MD Helicopters, LLC

***MD500/600 Series
Technical Bulletins Package***

This package contains a complete set of
all Technical Bulletins issued through:

22 August 2023

Figure 1. Grip Shown Installed on Fixture with Associated Tools

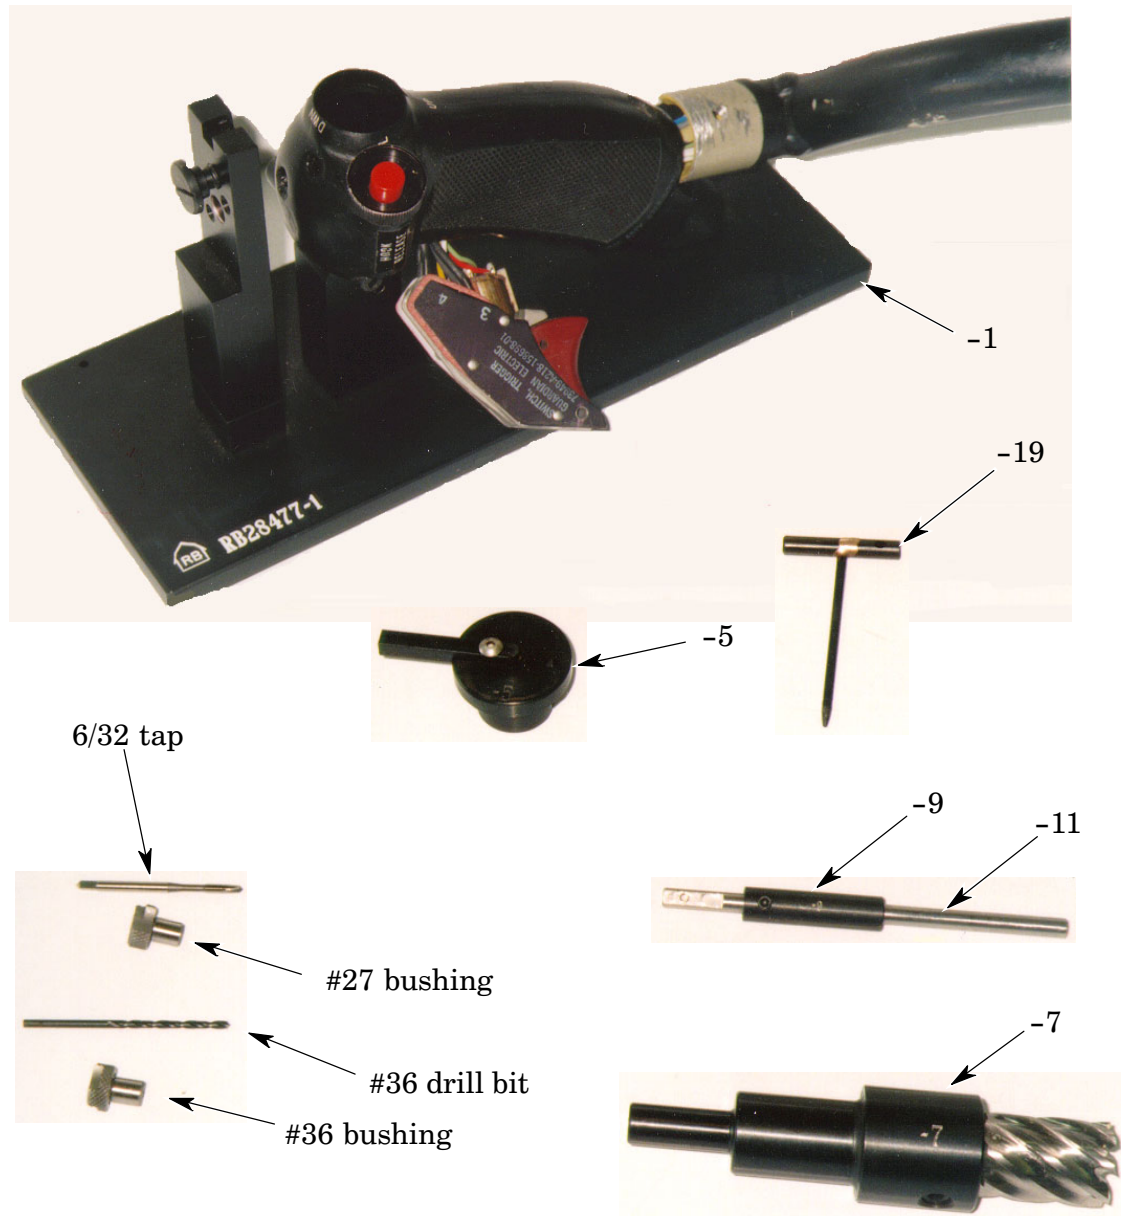
- (8). Install grip into fixture RBT 28477 (Figure 1, -1). Route wires at the bottom of grip over flat on fixture.
- (9). Install "T" pin (-19) into hole for trigger switch pivot pin to secure the grip to fixture RBT 28477 (-1).

**Figure 1. Installation - Engine Compressor Water Wash Kit, PN 369H92537
 (sheet 1 of 3)**

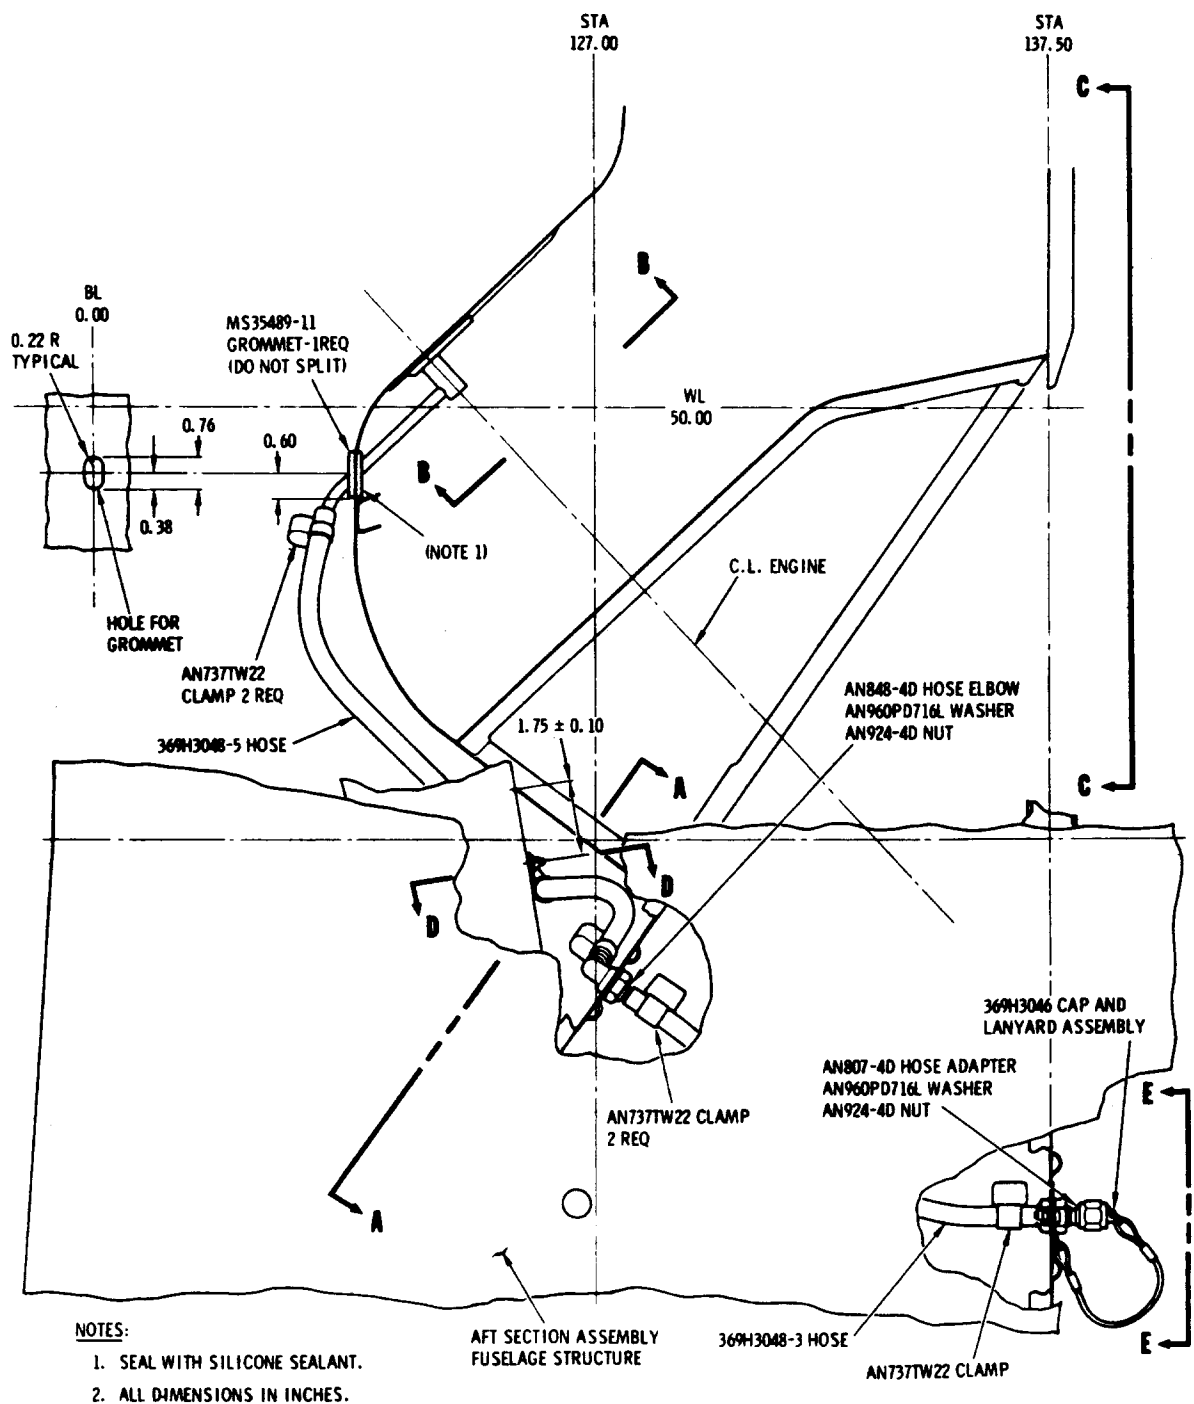
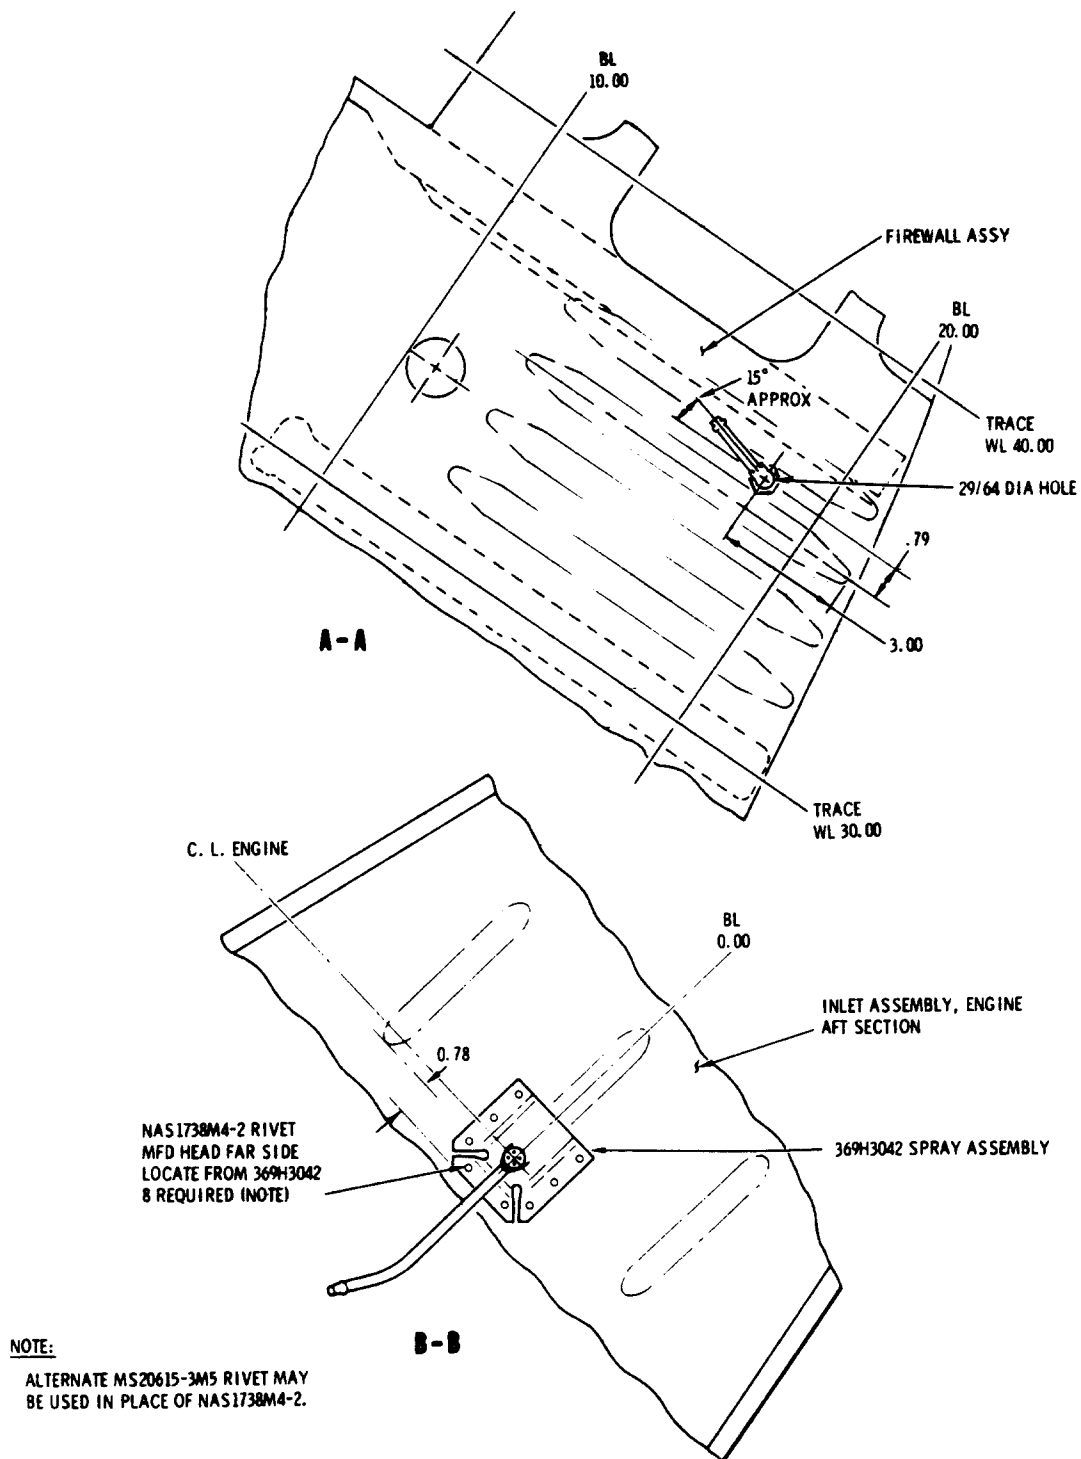
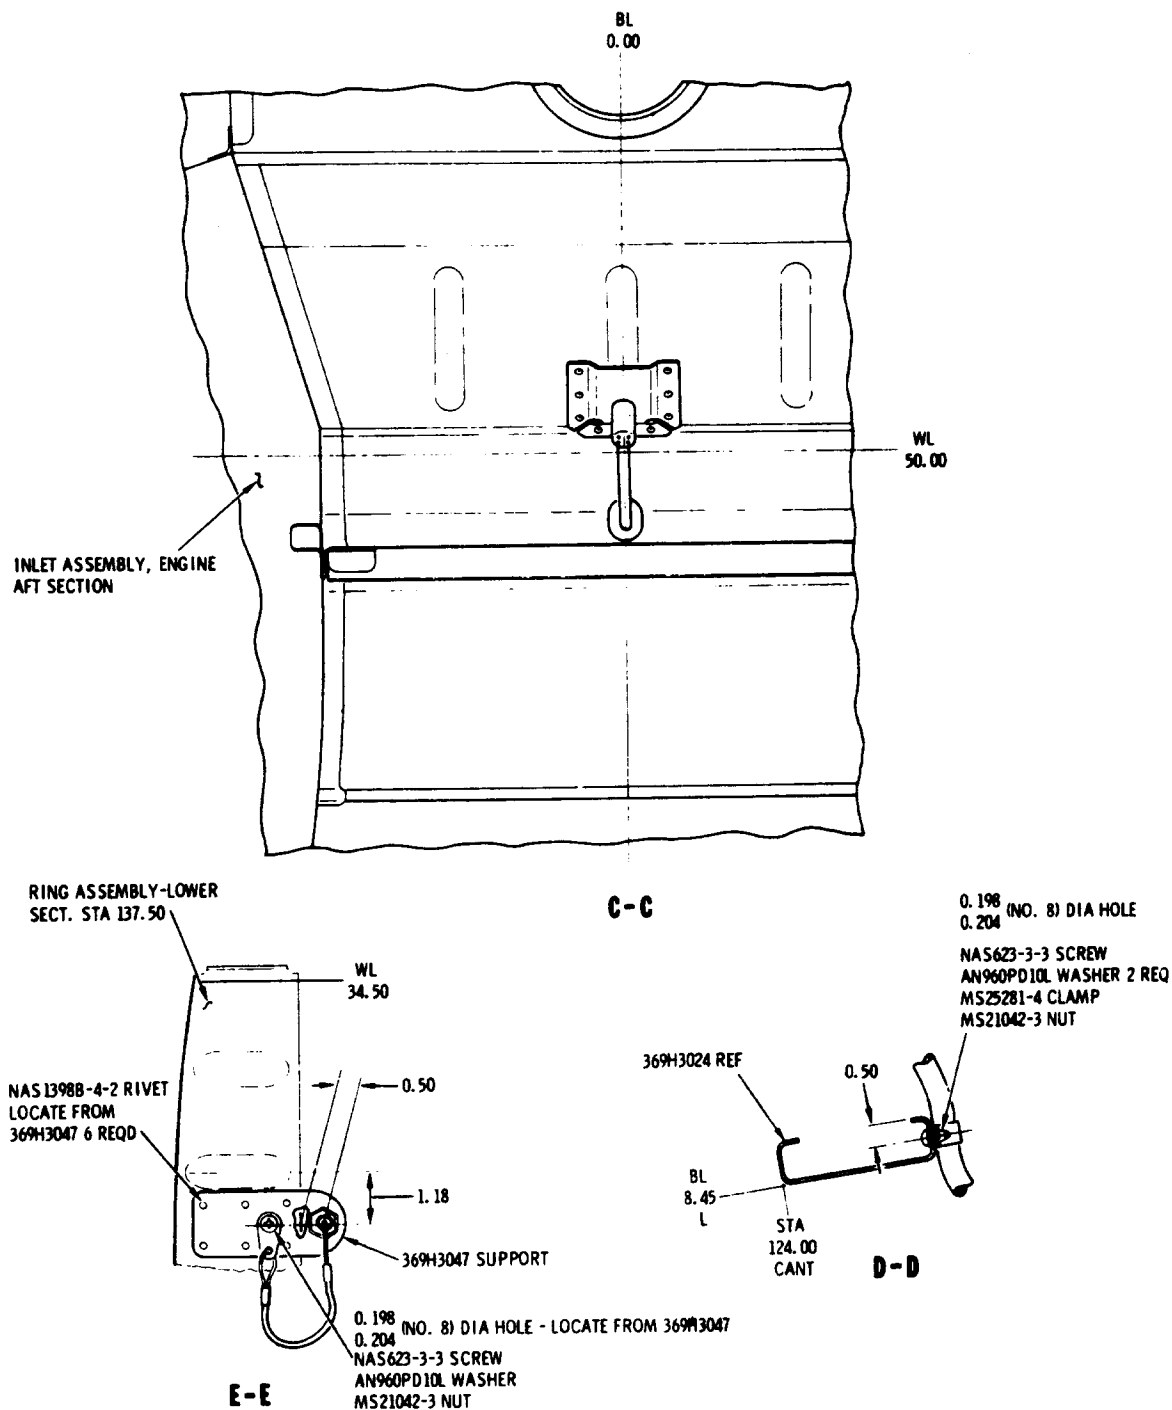
- (2). Position 369H3047 support on Station 137.50 lower section ring at dimensions shown in Figure 1, view E-E. Mark and drill rivet holes and install support with six NAS1398B4-2 rivets. Install rivets with zinc chromate primer.

- (6). Cut hole for MS35489-11 grommet in forward wall of plenum chamber per dimensions shown; install grommet with silicone sealant.
 - (7). Position 369H3042 spray assembly on inner side of plenum chamber forward wall as shown in Figure 1, view B-B, with tube inserted forward through grommet. Mark and drill rivet holes and install spray assembly with eight NAS1738M4-2 rivets. Install rivets with zinc chromate primer.

Figure 1. Replacement of Plenum Wall Fittings - Torque Pressure Gage Tubing and Engine Oil Pressure Gage Tubing

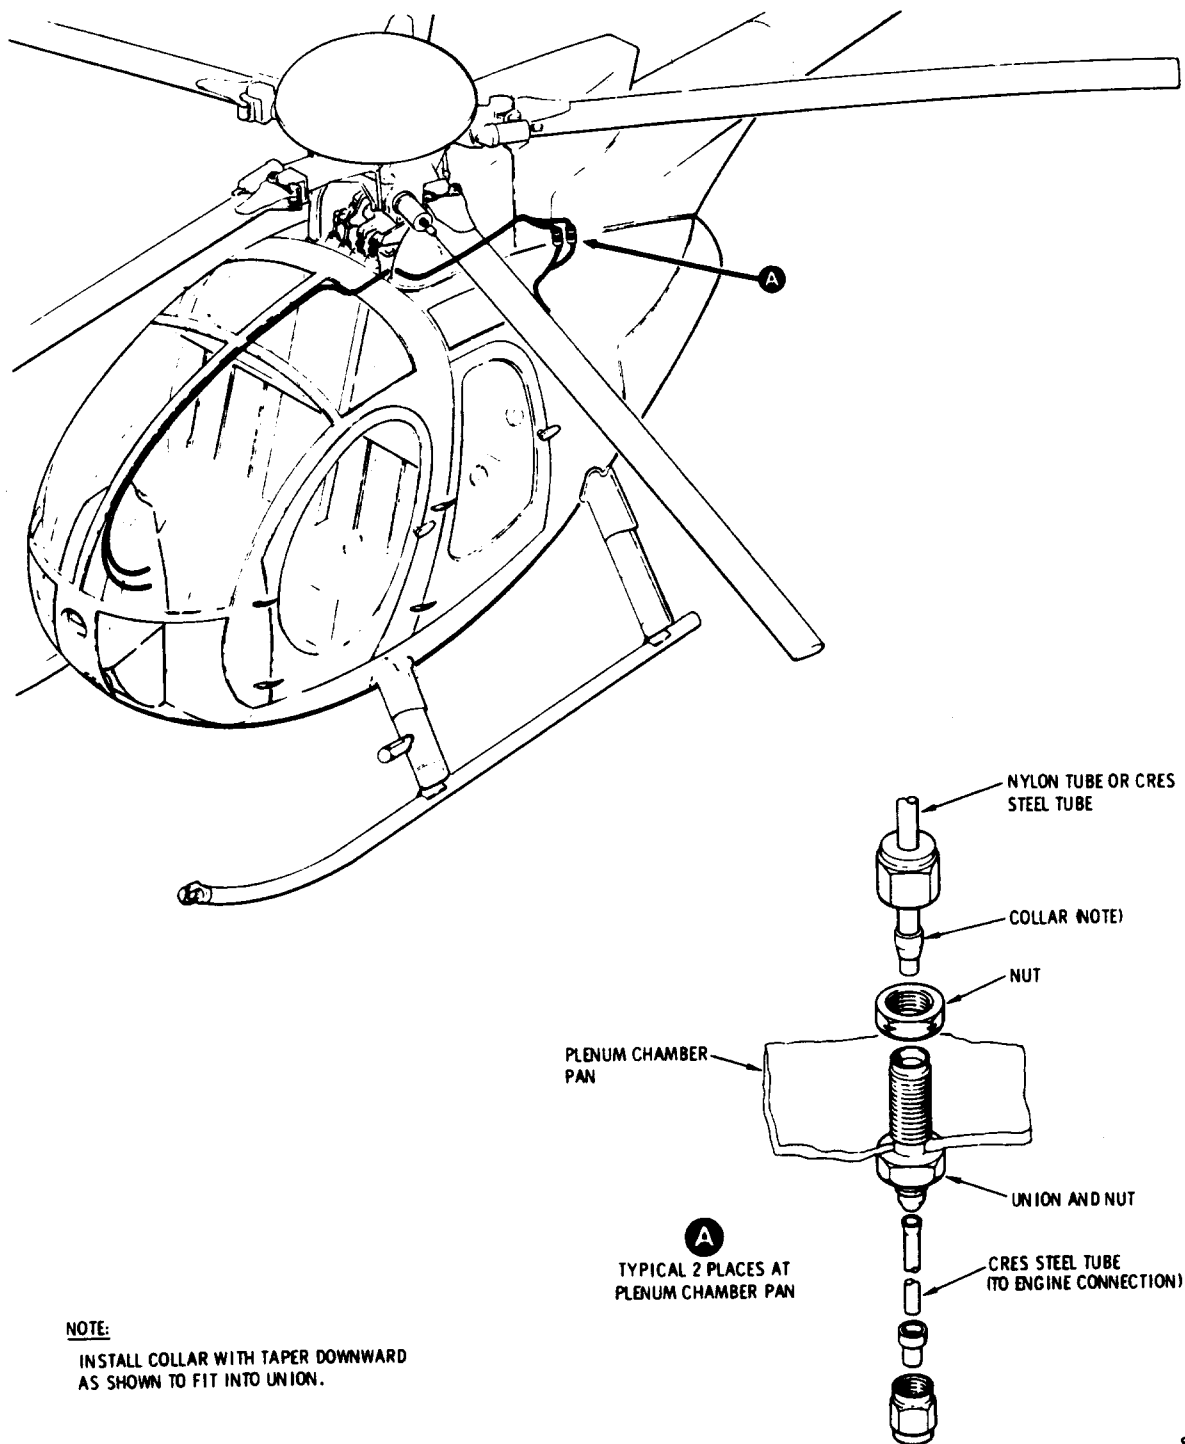
- (5). Remove existing fittings (reducers and unions) from plenum chamber pan.
- (6). Install new ASI 2-3XH2BZ-SS-T fittings at plenum chamber pan, as shown in Figure 1.

Figure 1. Inspection and Repair - Main Rotor Drive Shaft

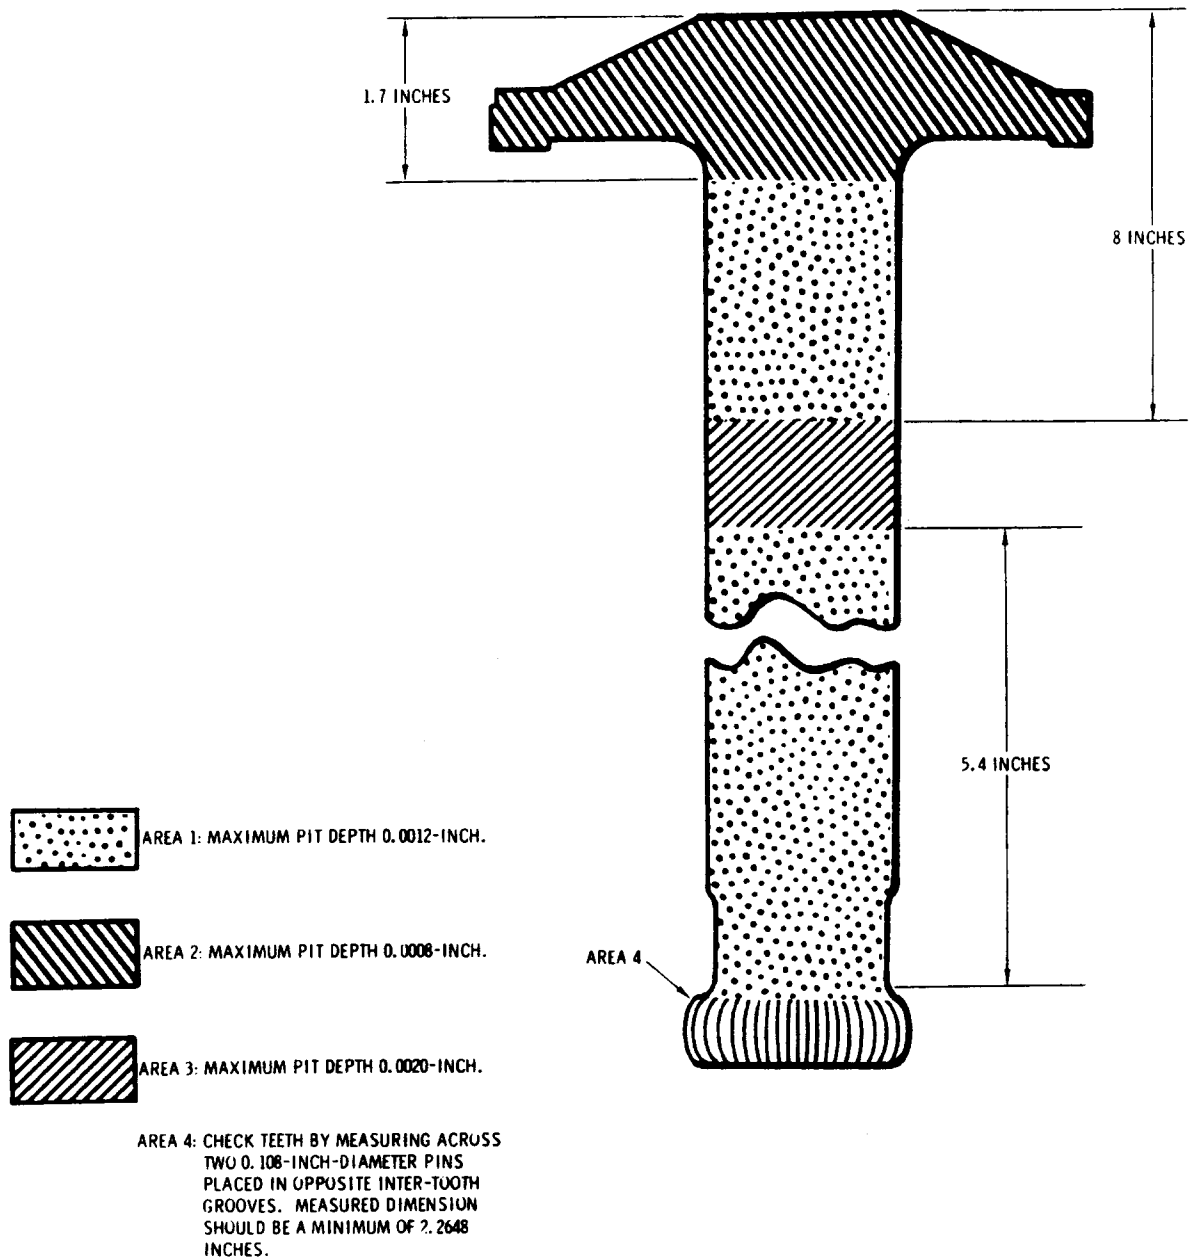
Exercise care when removing pits to ensure that shot peening is not completely penetrated. Also, remove only minimum material necessary to remove pits. Minimum wall thickness of 0.1775 inch must be maintained.

- (d). Lightly abrade corroded surface with crocus cloth to remove pits. If pit removal exceeds depth of 0.0012-inch in Area 1 or 0.0008-inch in Area 2 (See Figure 1), shaft is unserviceable and must be replaced.
 - (e). Repeat 1 through 3 above.
 - (f). Spray two coats of zinc chromate primer on shaft exterior. Do not prime spline teeth or mounting surface.
- (4). Apply preservative oil to spline teeth.
- (5). Immediately reinstall main rotor drive shaft, per Basic HMI.
- (6). Apply a 0.06-inch bead of sealing compound around interface of hub and drive shaft.
